RE: Florida Power Corporation
Construction Permit Amendments
AC64-191015, PSD-FL-167, DeBary
AC49-203114, PSD-FL-180, Intercession City

Re: Request to Amend DeBary Construction Permit AC 64-191015 PSD-FL-167
Request to Amend Intercession City Construction Permit AC 49-203114 PSD-FL-180

New DeBary and Intercession City Combustion Turbines

GE Frame 7EA Combustion Turbines

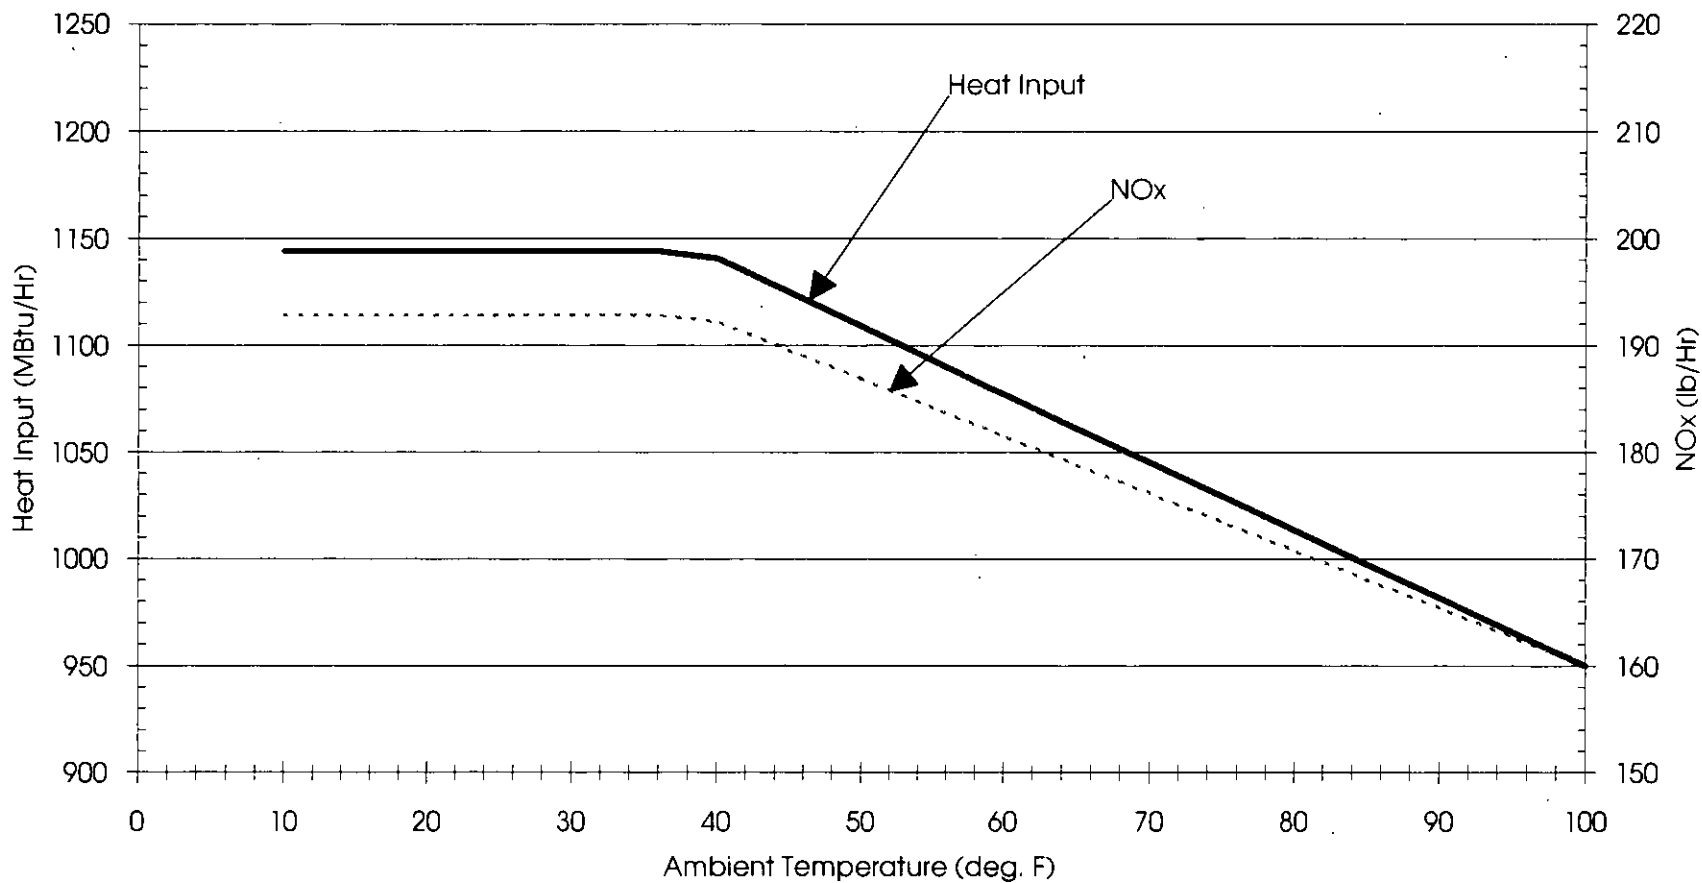
FPC submits the attached heat input vs. ambient temperature curve for application to both the DeBary and Intercession City new combustion turbines. For DeBary, FPC requests that the curve be incorporated into the construction permit. FPC will then request that the Central District amend the operating permit accordingly.

For the new GE Frame 7EA combustion turbines at Intercession City, FPC requests that the DEP remove the current specific ambient temperature and heat input references contained in Specific Condition 4.D. The attached curve would then be incorporated into the construction permit, replacing the specific references.
